McNICHOLS® PERFORATED METAL

NOT TO SCALE	
DWG NUMBER	REVISION
18335316	A

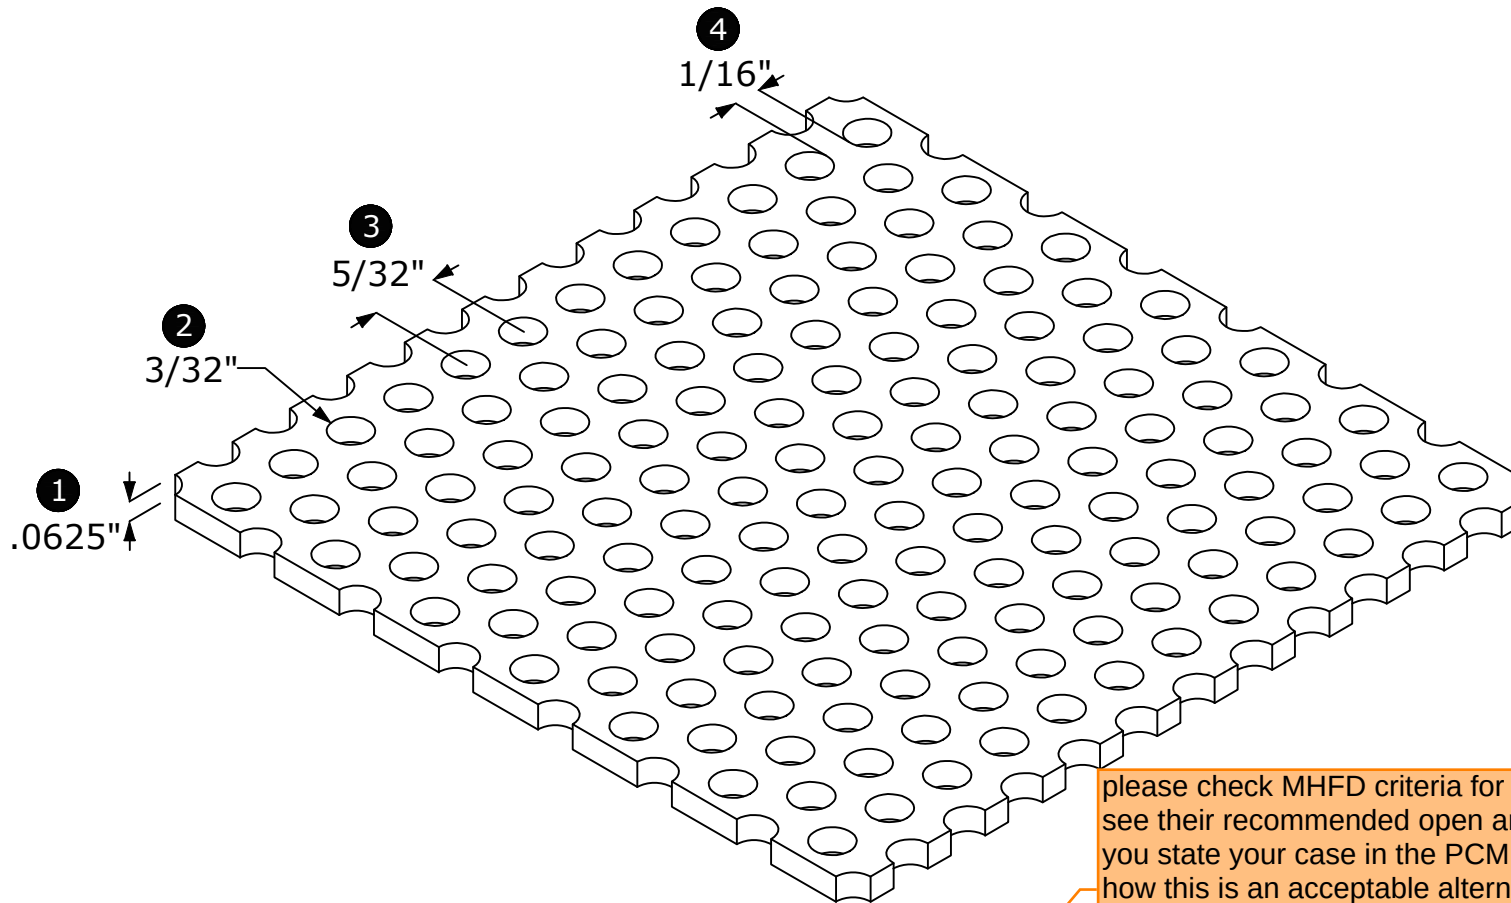
please check MHFD criteria for microscreens to see their recommended open area. That will help you state your case in the PCM Cert Letter as to how this is an acceptable alternative. Likewise, find the open area of the vee wire on the original design to show how this is an equivalent alternative to that.
